**MONTGOMERY COUNTY HISTORIC PRESERVATION COMMISSION**  
**STAFF REPORT**

<b>Address:</b>	7420 Maple Avenue, Takoma Park	<b>Meeting Date:</b>	2/12/2020
<b>Resource:</b>	Contributing Resource <b>Takoma Park Historic District</b>	<b>Report Date:</b>	2/5/2020
<b>Applicant:</b>	Sonja Prince	<b>Public Notice:</b>	1/29/2020
<b>Review:</b>	HAWP	<b>Tax Credit:</b>	n/a
<b>Case Number:</b>	37/03-20I	<b>Staff:</b>	Dan Bruechert
<b>PROPOSAL:</b>	Solar Panel Installation

Staff recommends the HPC **approve** the HAWP application.

Figure 2: Roof plan showing the placement of the 53 solar panels. The historic roof form is outlined by the red box.

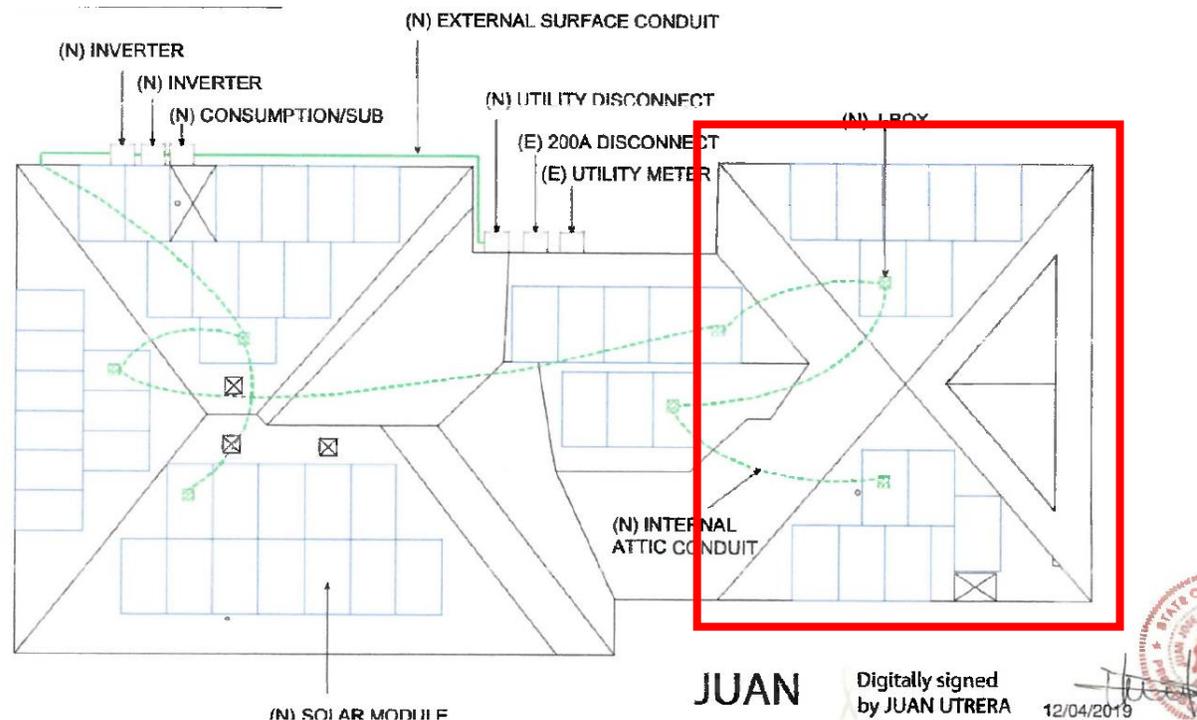
The applicant proposes installing 53 (fifty-three) solar panels in 7 arrays on the north, south, and western roof slopes. No panels are proposed for the front-facing, east roof slope. The black panels will be attached to the roof using a CrossRail system that will project approximately 5" (five inches) above the roof surface.

On the historic roof, the applicant proposes installing two arrays, one with six panels on the south slope and a seven-panel array on the north roof slope. The south array will only be visible from an oblique angle from Maple Ave. The array on the north roof slope will be more visible from Old Philadelphia Ave. However, neither of these arrays will detract from the foursquare form that makes the subject property architecturally significant to the surrounding district, per 24A-8(b)(2). The CrossRail system employed to mount the solar arrays will penetrate the asphalt shingle roof, but Staff does not find this roofing to be historically significant, per Standards 9 and 10.

On the 1942 addition, the applicant proposes installing five arrays; two on the hyphen, and one each on the north, south, and west slopes of the rear addition. As these roof sections are not historic and do not substantially contribute to the character of the surrounding district, a more lenient review should be granted under 24A-8(d). Staff finds that the two arrays on the south-facing roof slopes will not be at all visible from the right-of-way and should be approved as a matter of course under the *Design Guidelines*. Staff further finds the array on the west-facing roof slope is the rear of the house which is the least architecturally significant elevation. Staff does not find that a solar array in this location would impair the historic character of the surrounding district (24A-8(d)). The final two arrays are on the north-facing roof slopes. This will be visible from the Takoma Park Memorial Park across Philadelphia Ave., but will have only a minimal impact on the historic character of the subject property or surrounding historic district.

Staff recommends that the Commission **approve** the HAWP under the Criteria for Issuance in *Chapter 24A-8(b)(2)* and *(d)* having found that the proposal will not substantially alter the exterior features of the historic resource and is compatible in character with the district, the *Takoma Park Historic District Guidelines*, and the purposes of *Chapter 24A*;
